ADDENDUM No. 1

Project Name:	Owner: Charter Township of Canton Project Name: Canton Public Safety Building Renovations	**Addendum No:** One (1)
Project Number:	21-130	Issue Date: March 18, 2022
Project Location:	1150 South Canton Center Road, Canton Twp, MI 48188

This Addendum consists of (3) typed pages and the following (19) attachments:

SHEET NO. E3.1

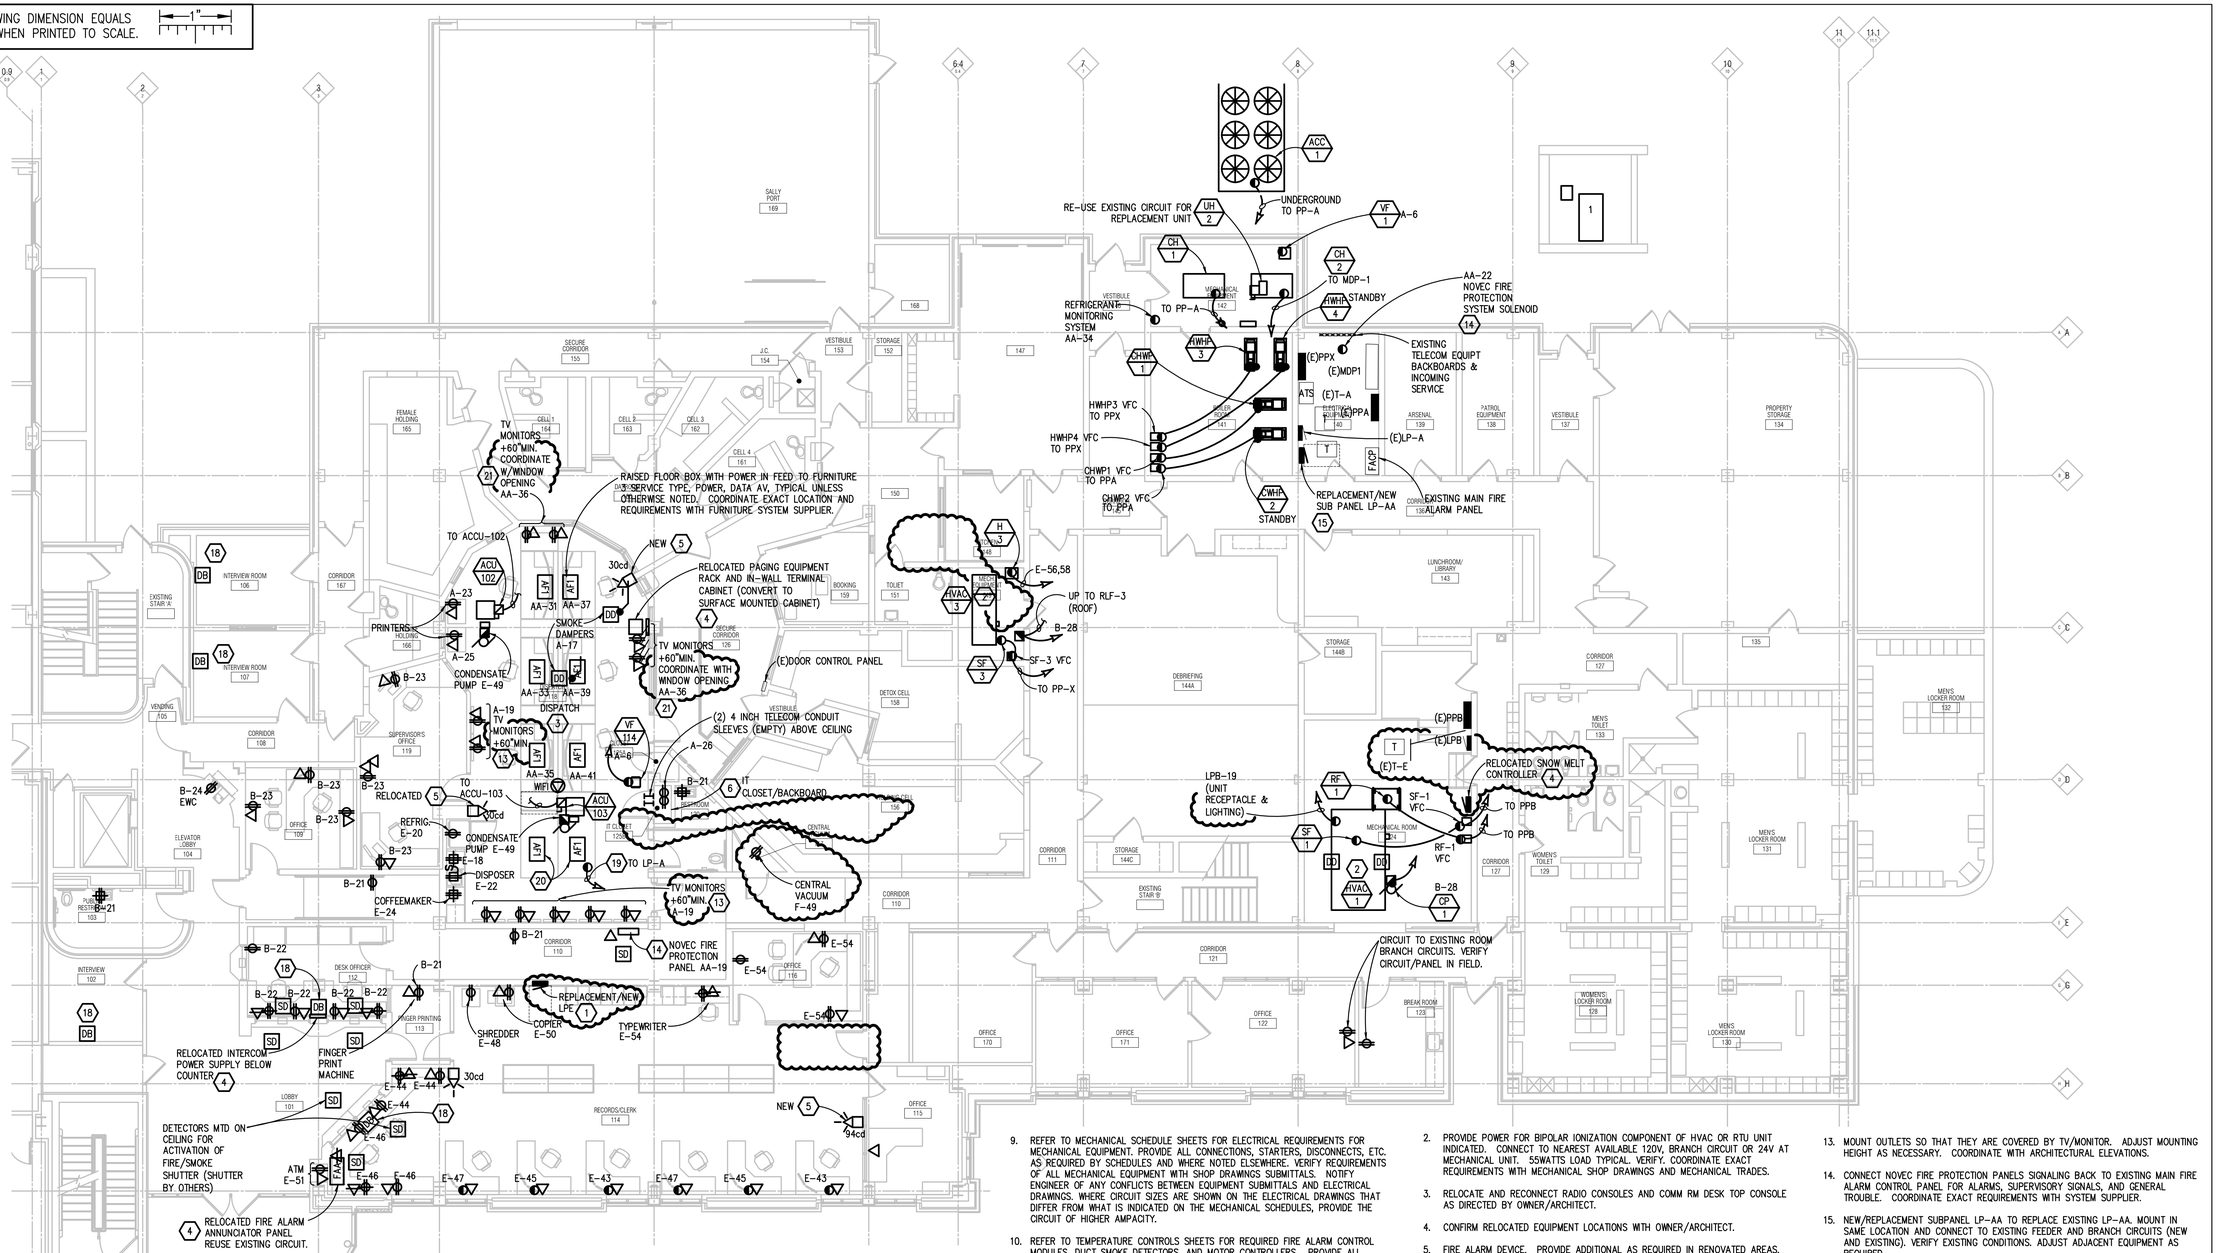
ITEM E1 E3.1 First Floor Power Plan (Revised & Re-Issued)

A. Relocated new panel LP-F to west wall of Records/Clerk 114.
B. Added receptacle and branch circuit for central vacuum system power in Central Vacuum 117.
C. Revised TV monitor outlets mounting heights and notes in Dispatch 118.
D. Relocated Existing Snow Melt System controller from Dispatch 118 to Mech Rm 124. Adjusted existing transformer location in Mech Rm 124 on plan for clarity.
E. Deleted branch circuit for HVAC-3 receptacle and control.
F. Clarified HVAC-1 circuiting notation for LPB-19.

SHEET NO.
E3.2

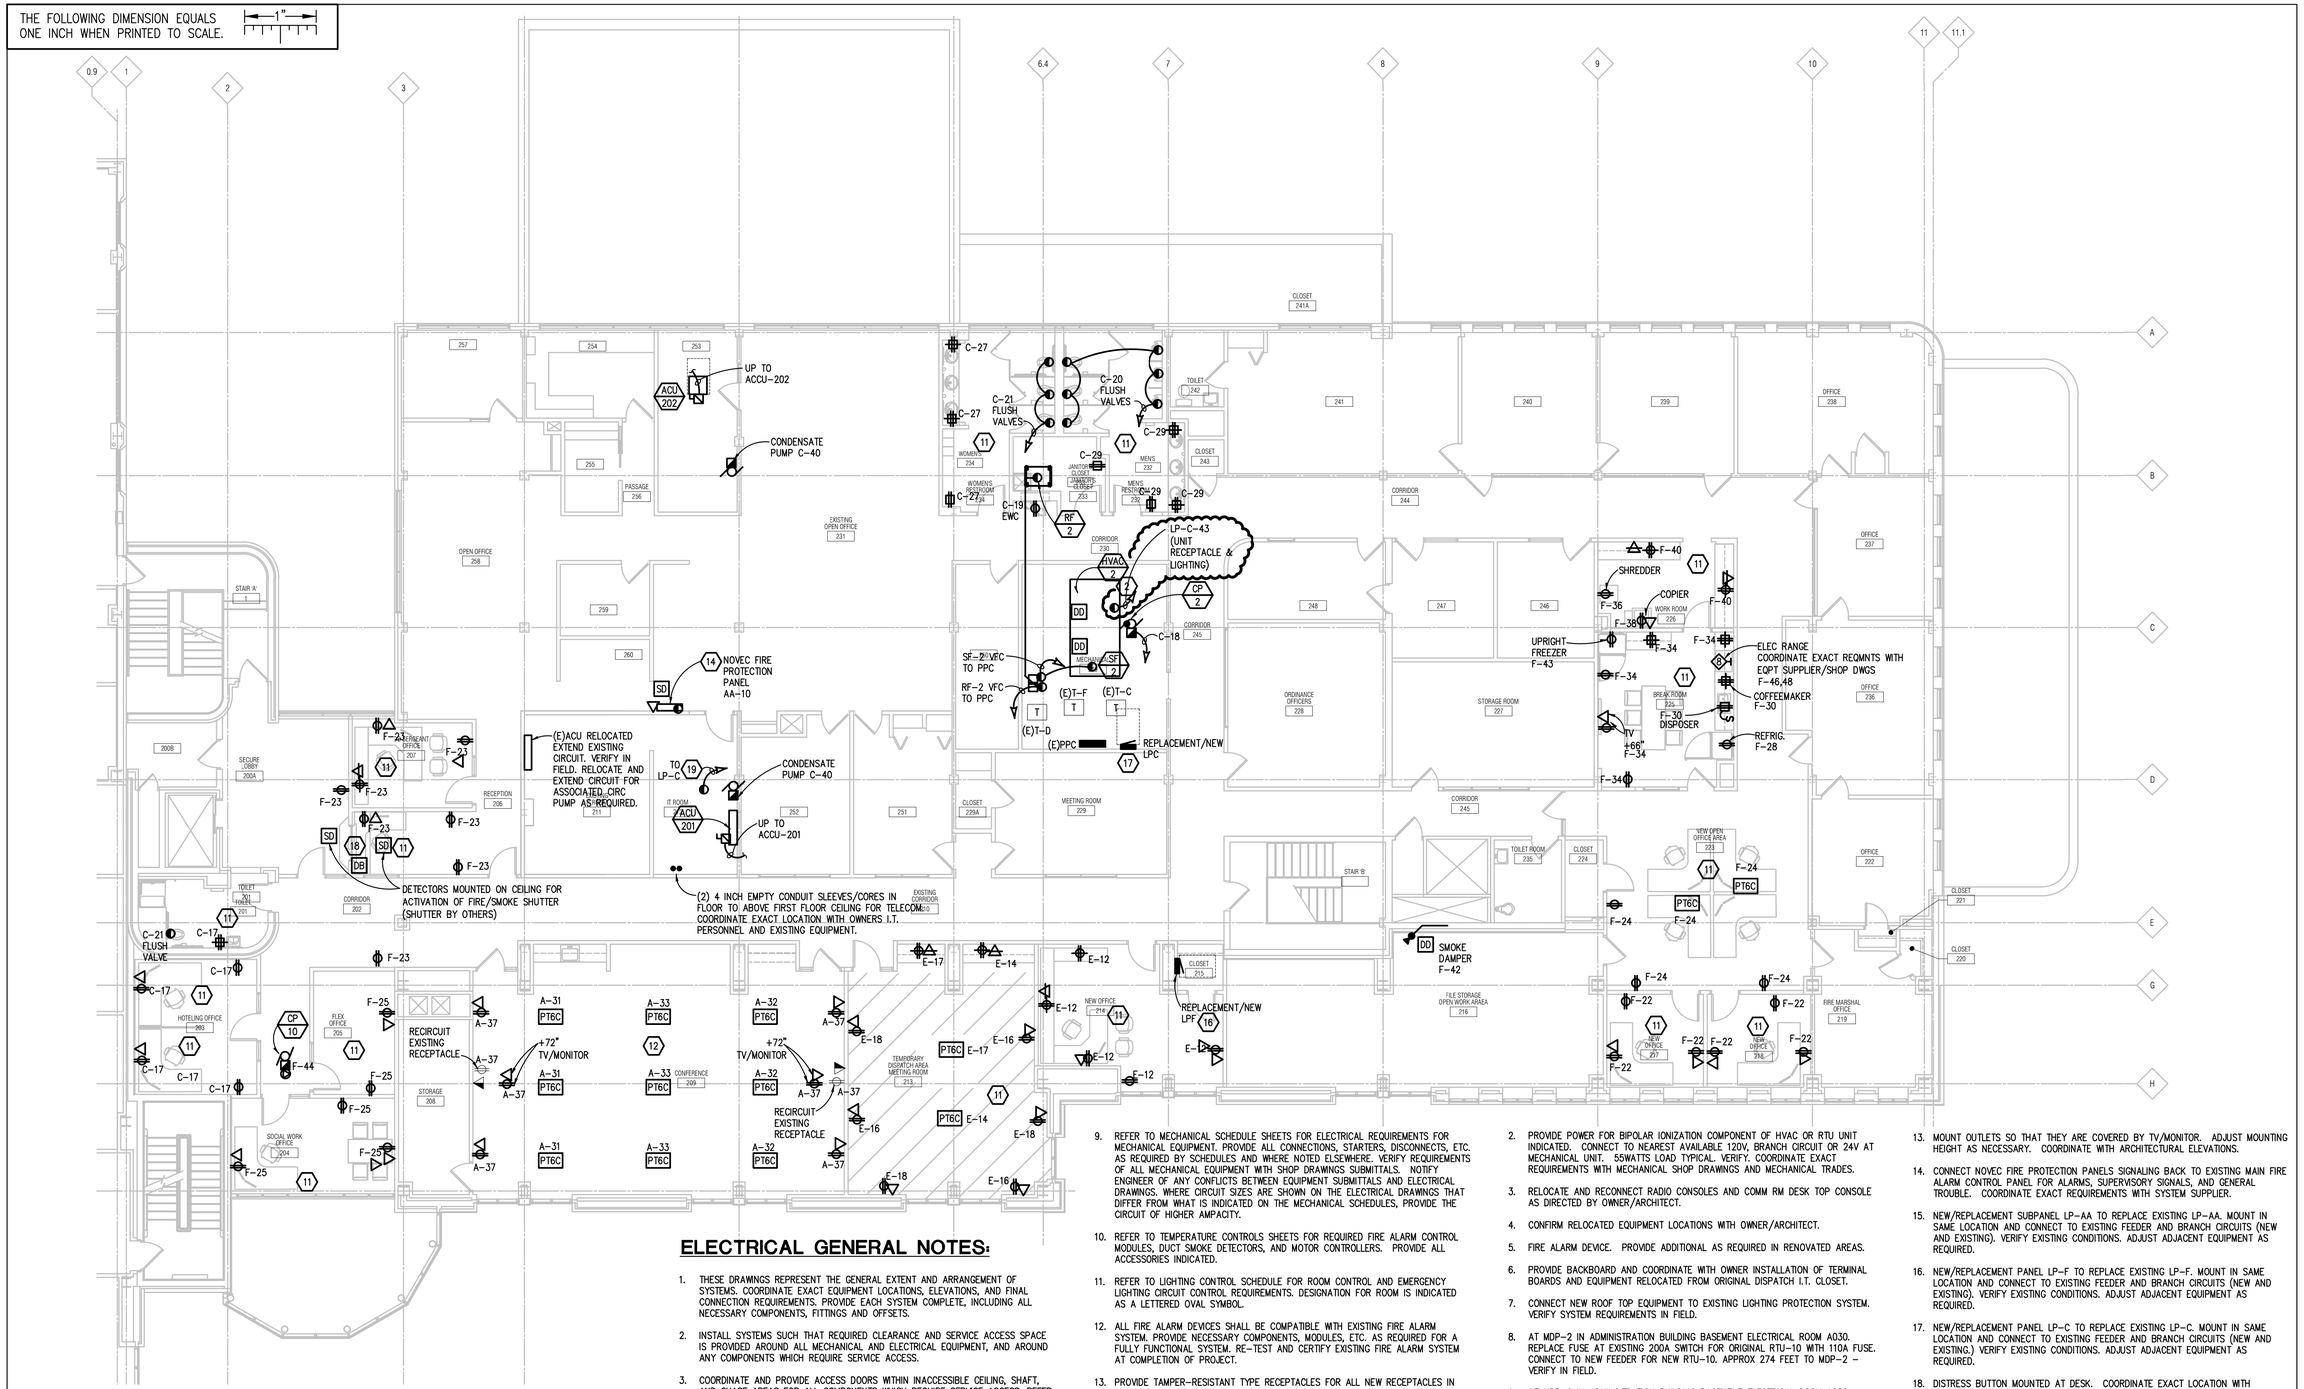
ITEM E2 E3.2 Second Floor Power Plan (Revised & Re-Issued)

A. Added branch circuit for HVAC-2 receptacle and lighting.

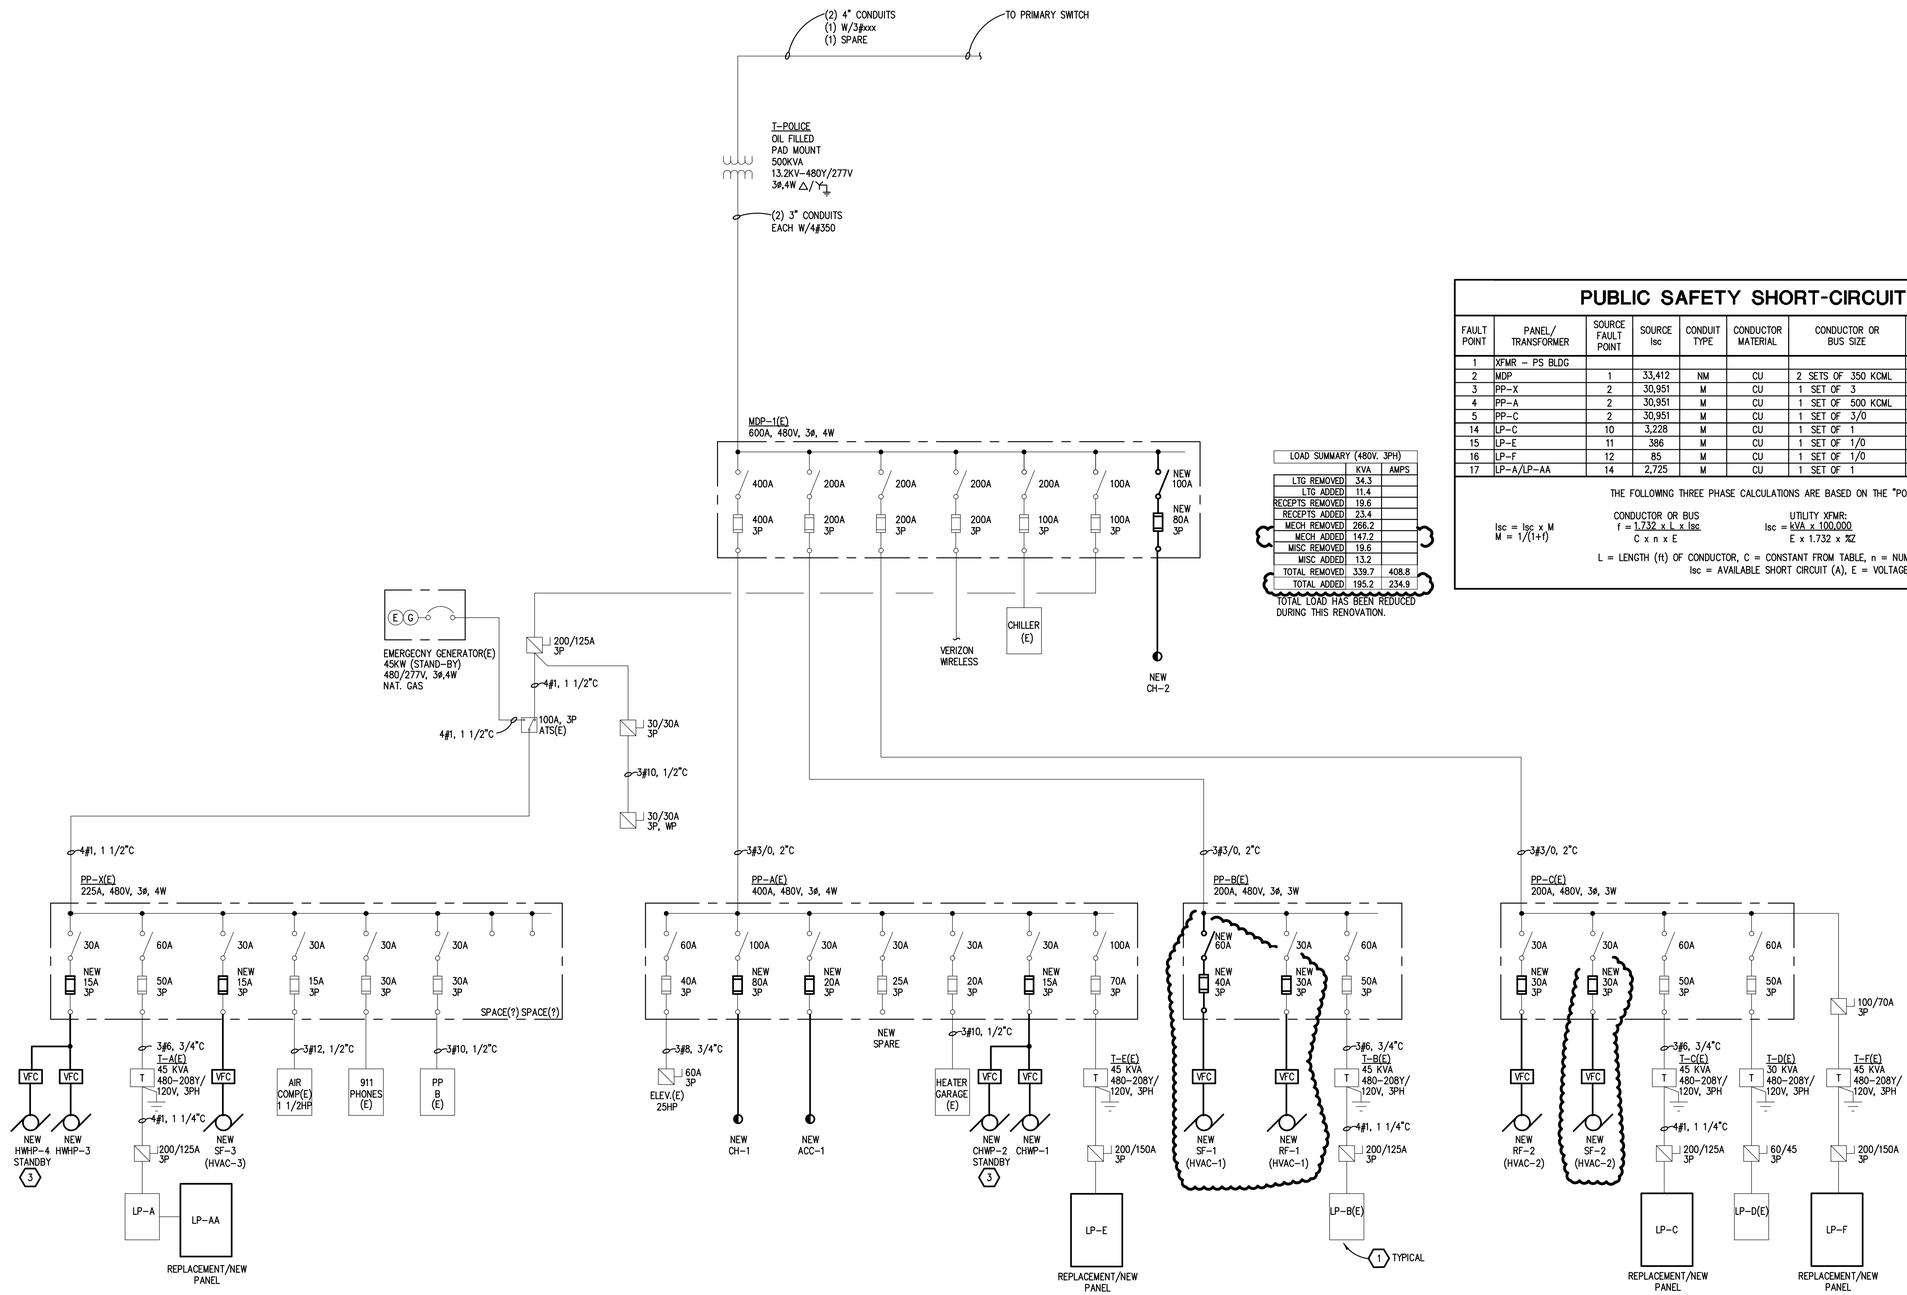
ITEM E3 E5.2 One Line Diagram (Revised & Re-Issued)

A. Revised new power for new SF-1 and new RF-1 at existing PP-B.
B. Revised new power for new SF-2 at existing PP-C.
C. Revised Load Summary.
